Project No. 2021\_154

MIDLOTHIAN ISD STADIUM ADDITIONS AND RENOVATIONS

ADDENDUM NO. 2

DATE: October 18, 2021

NO MECHANICAL SCOPE IN  
HATCHED CONCESSION  
AREA & TICKET BOOTH AT  
EACH BUILDING.

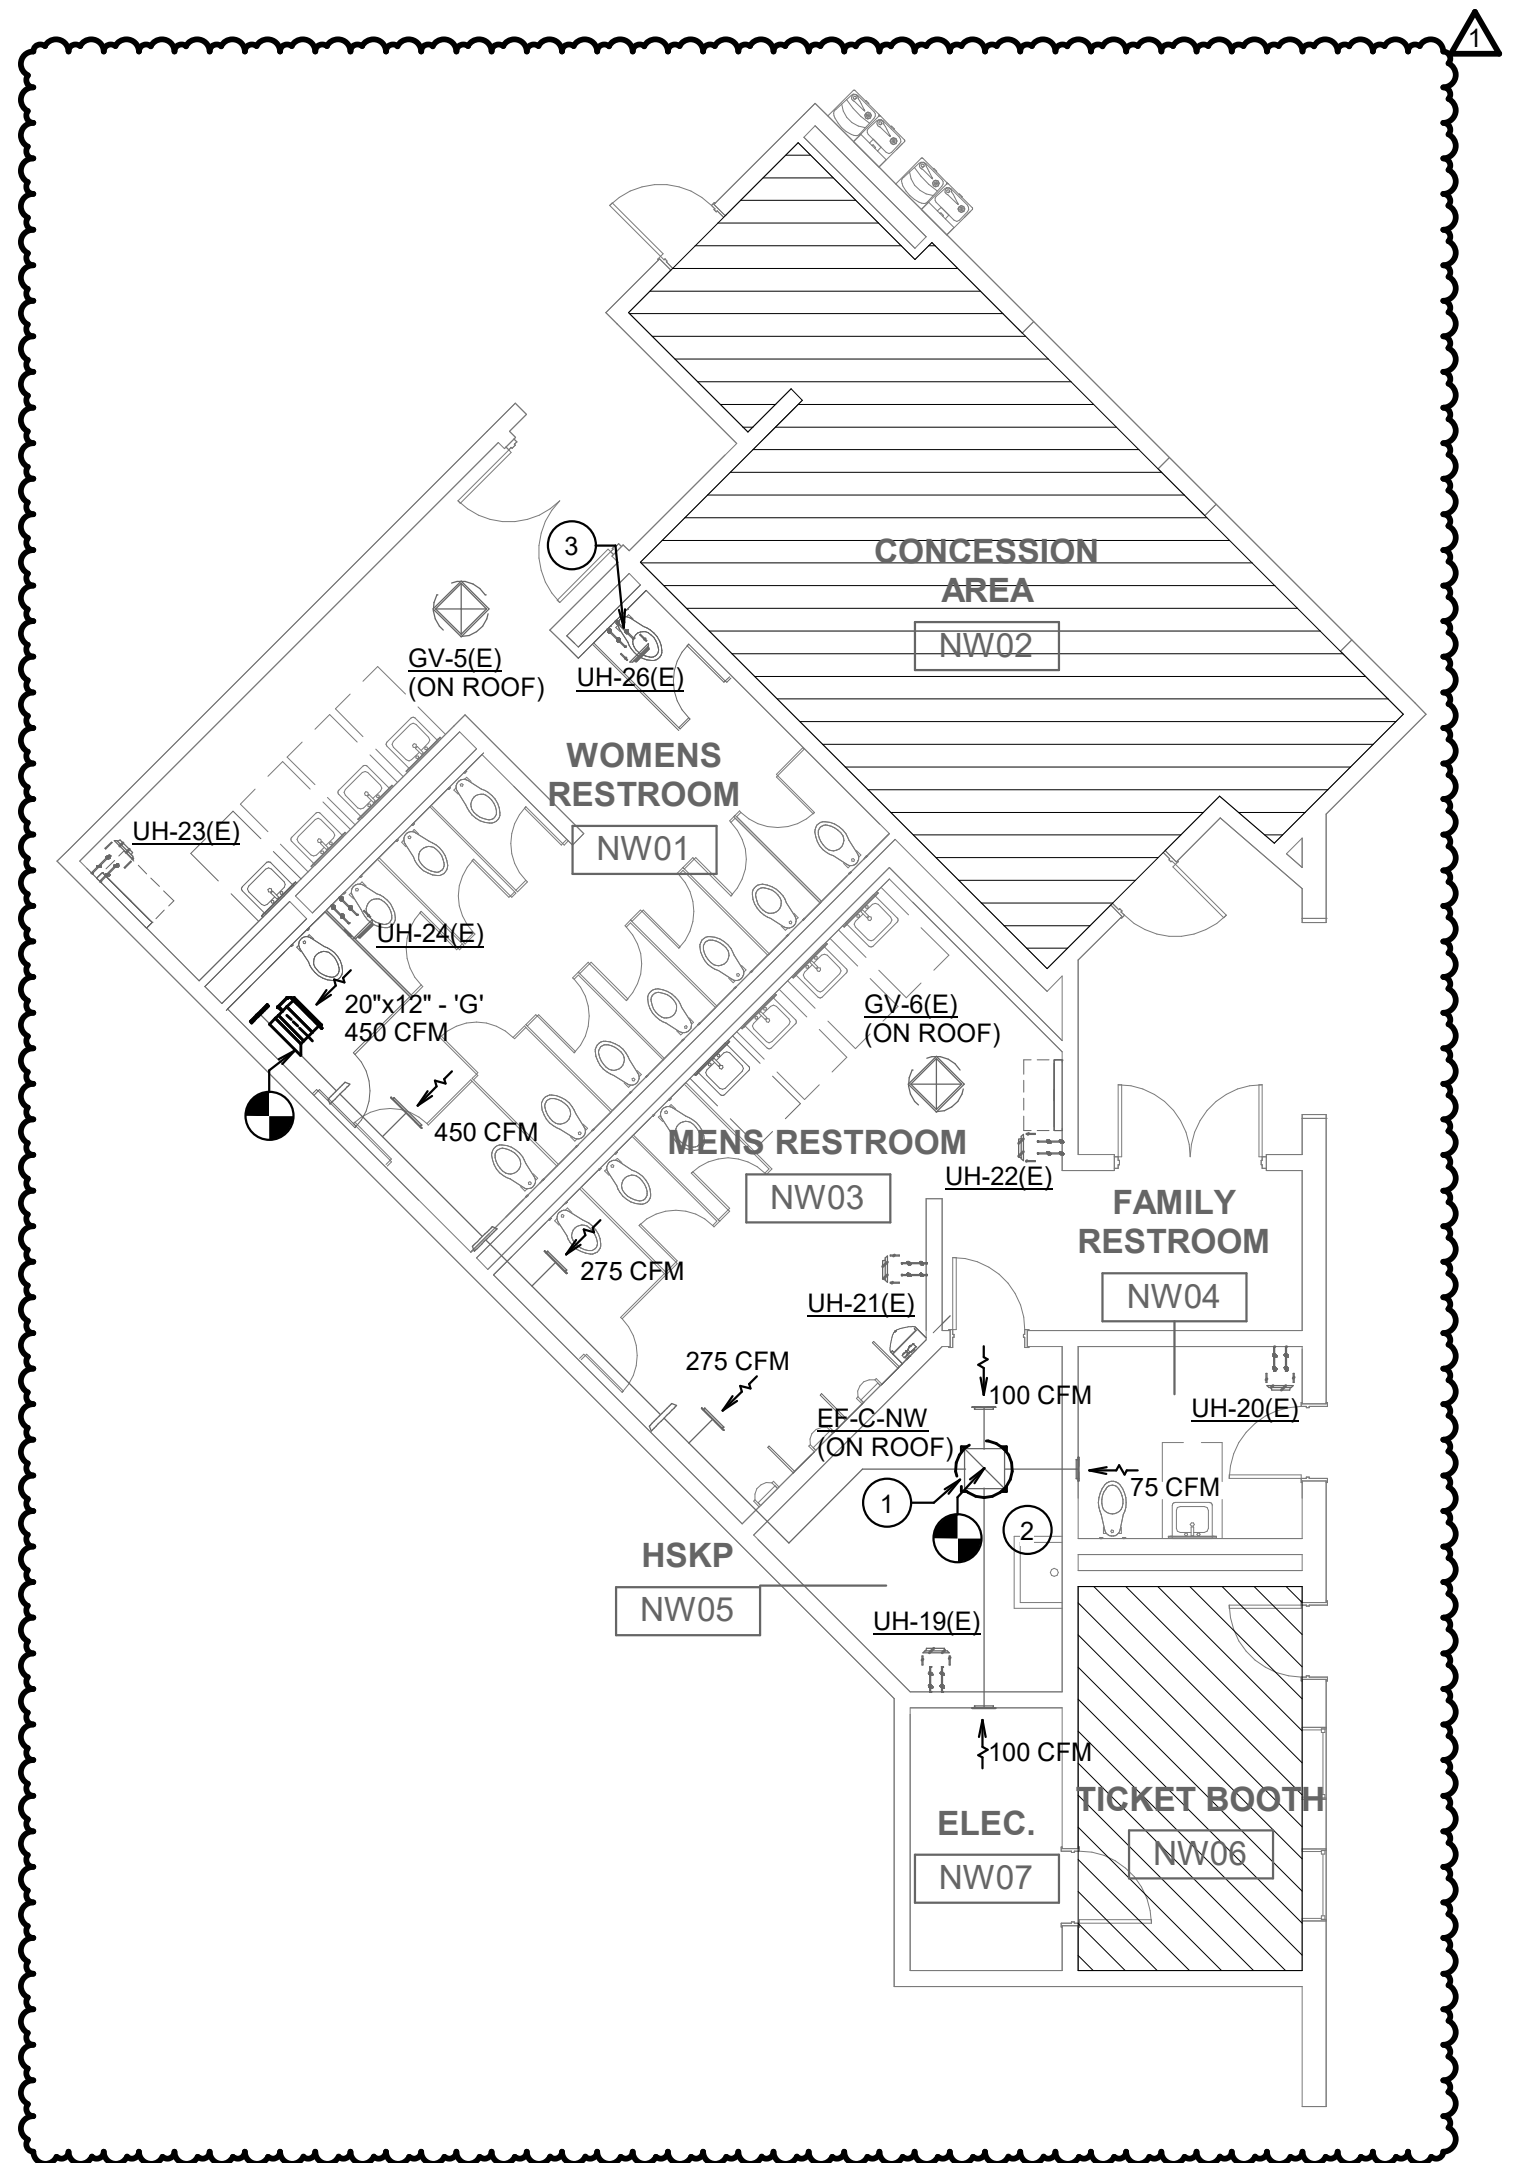
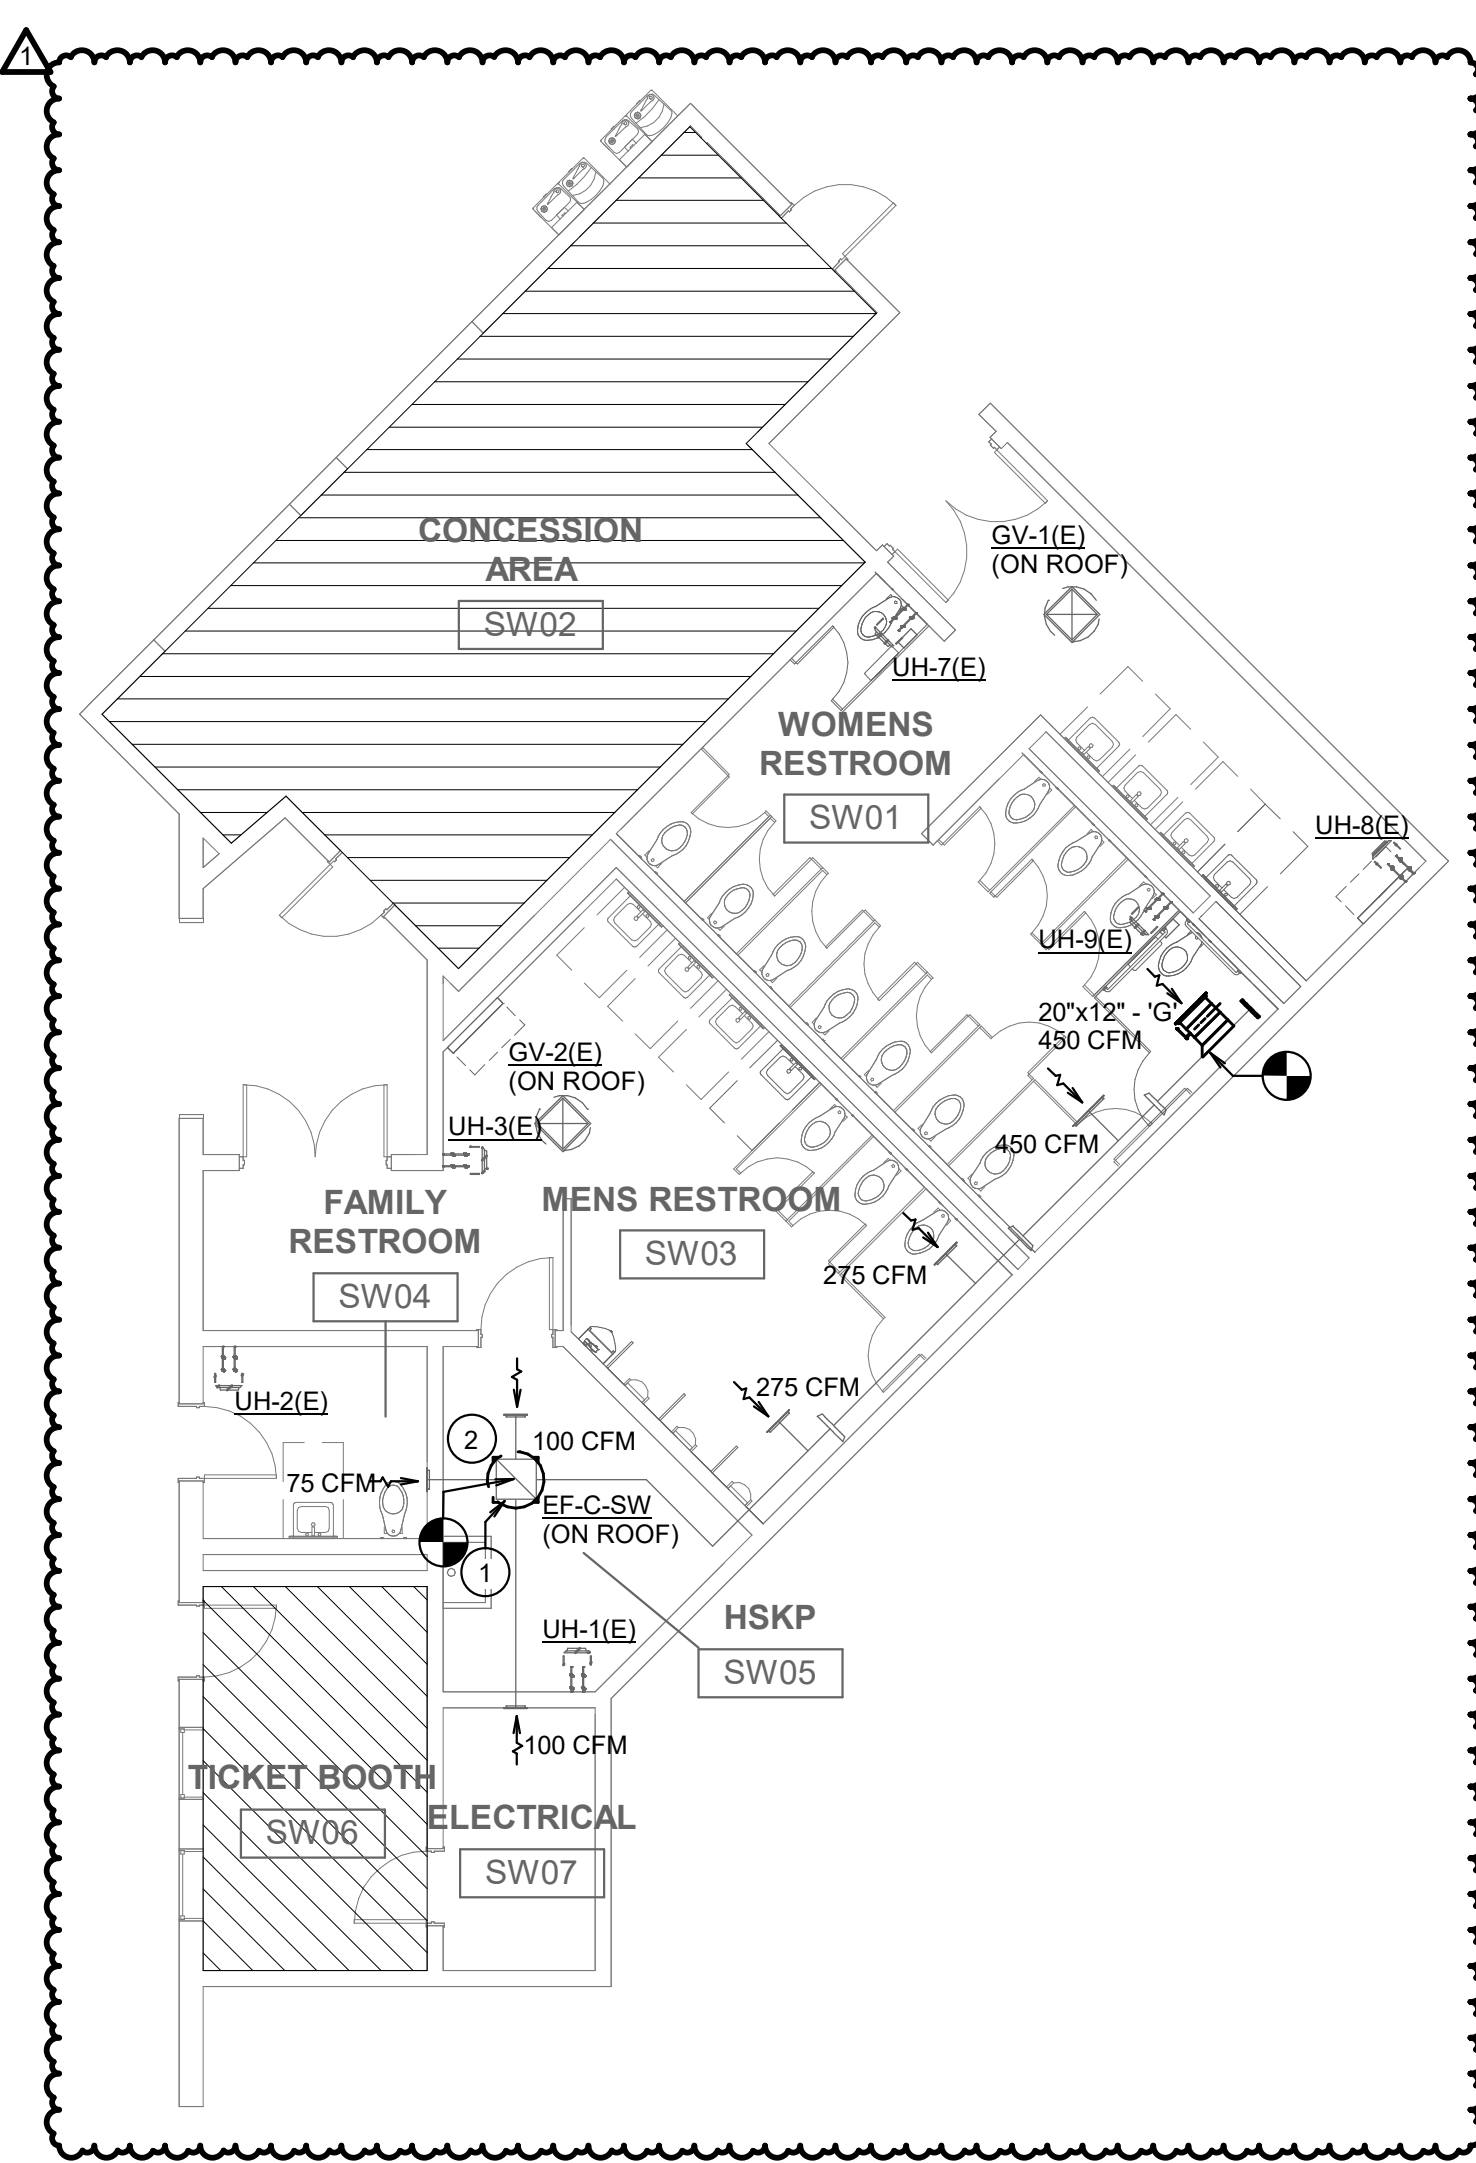
- a. Revised HVAC exhaust grilles tags to clarify the scope of work in each concessions building.
  - b. Revised Exhaust fan schedule and 'Notes by Symbol' as shown on the attached drawing.

PROJECT TEAM DRAWN BY  
ED TEXAS RWB  
PROJECT PHASE  
CONSTRUCTION DOCUMENTS  
SHEET CONTENTS  
FLOOR PLAN - PRESS BOX - HVAC  
SHEET NO.  
M-113

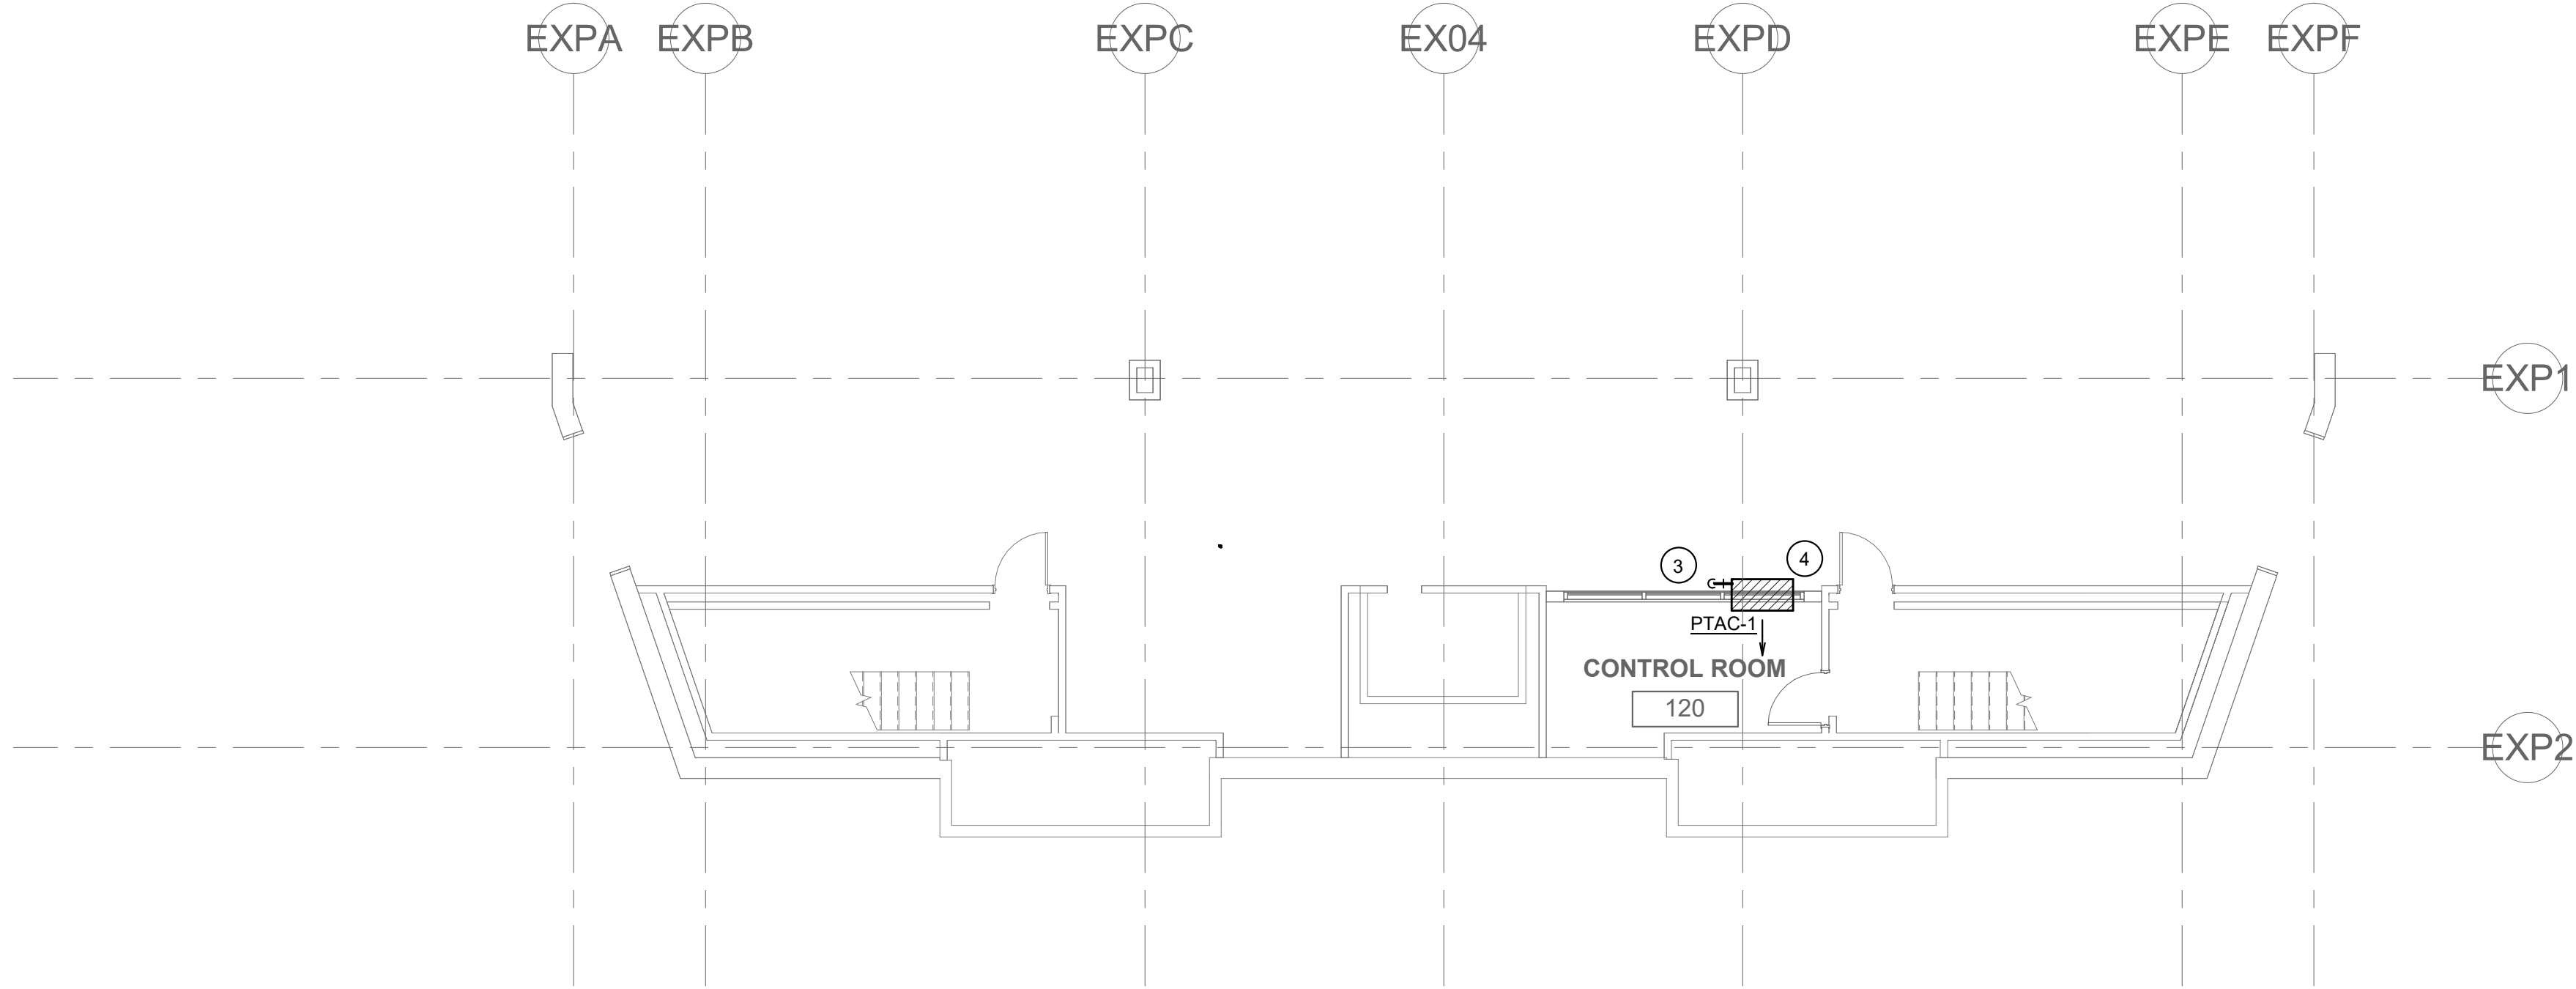
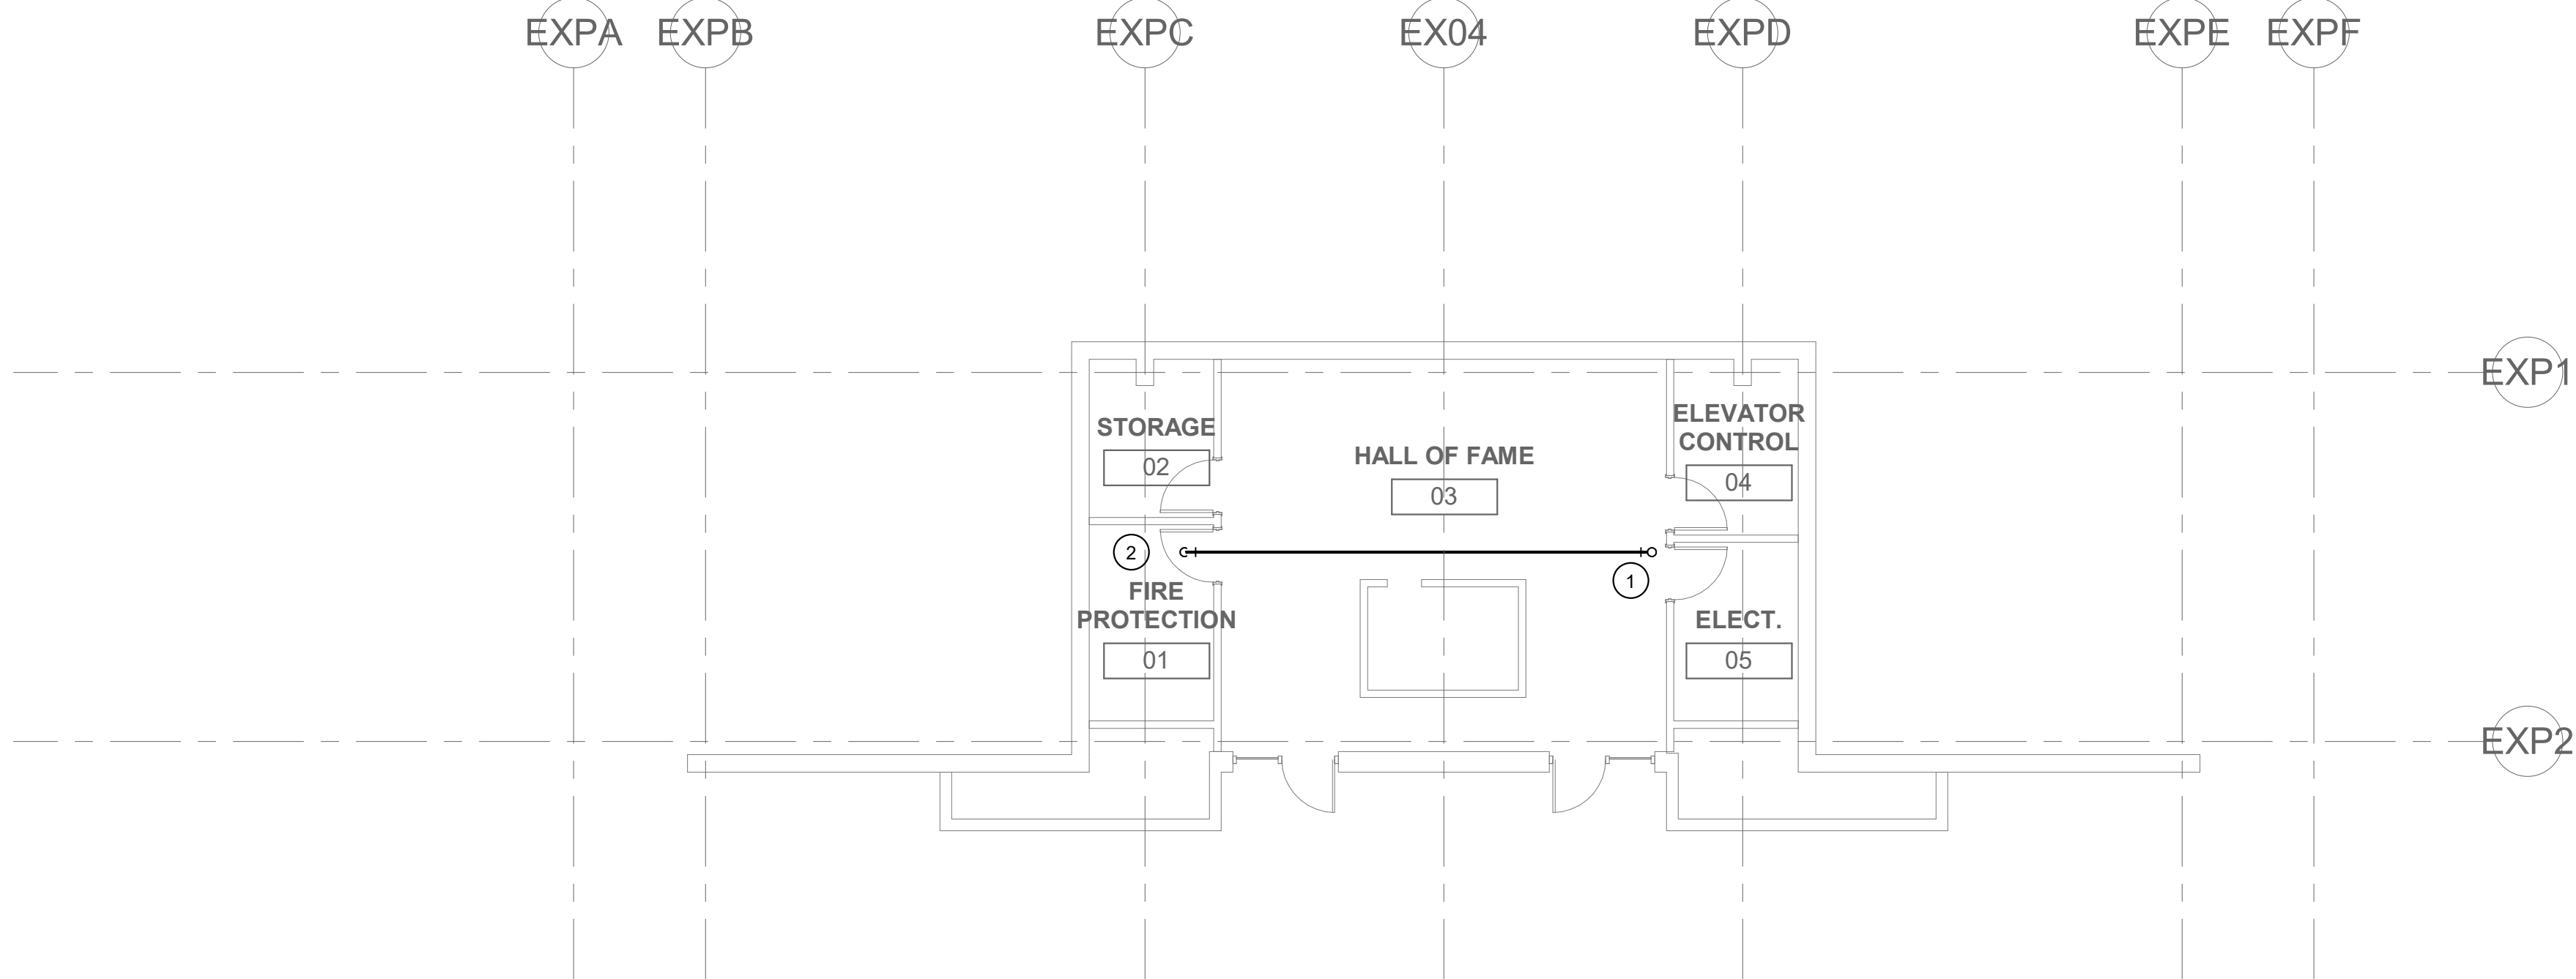
- A2.31 SHEET M-113 – FLOOR PLAN – PRESS BOX – HVAC:  
ADDED this sheet in its entirety.
- A2.32 SHEET M-302 – MECHANICAL ROOM SECTIONS – HVAC:  
ADD in its entirety
